UNITED STATES PATENT AND TRADEMARK OFFICE

Office Action Summary	Application No. 10/579,532	Applicant(s) IP, KAM WAH WILSON
	Examiner MARIA J. LAIOS	Art Unit 1795

DETAILED ACTION

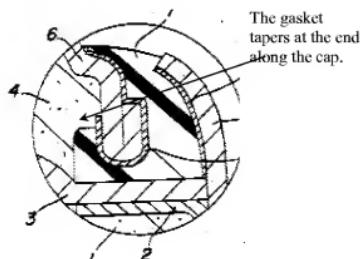
With respect to claim 1, Watanabe discloses a button alkaline battery cell comprising an cathode shell (5) containing an cathode mixture (1), said cathode shell (5) being interlocked with a anode cap (6) containing a anode mixture (4), the anode cap having outward flange, a separator (3) between the anode mixture and the cathode mixture, a gasket (7) fastened on the outward flange, wherein said gasket has a bottom and an outer wall and is placed on the separator (3), wherein an open-end portion of said cathode shell and an upper end portion of the outer wall of the gasket are bent to the anode cap (see figure 1), the upper end portion of the outer wall of the gasket is pressed against the outer surface of the anode cap; and wherein a sealant layer (8) is filled in an interspace formed between the flange of the anode cap and the gasket (see figure 2).

With respect to claim 2, Watanabe discloses the button alkaline battery cell wherein the gasket further comprises an inner wall, the bottom, the inner wall and the outer wall of the gasket form a groove, the flange of the anode cap is located in the groove of the gasket, and a sealant layer is filled in the interspace between the flange of the anode cap and the bottom, the inner wall, the outer wall of the gasket (see figure 2).

With respect to claim 3, Watanabe discloses the button alkaline battery cell the thickness of the inner wall of the gasket decreases along its upward direction (see figure 2 below).

With respect to claim 5, Watanabe discloses the button alkaline battery cell according the flange of the anode cap is U-shaped (see figures 1 and 2).
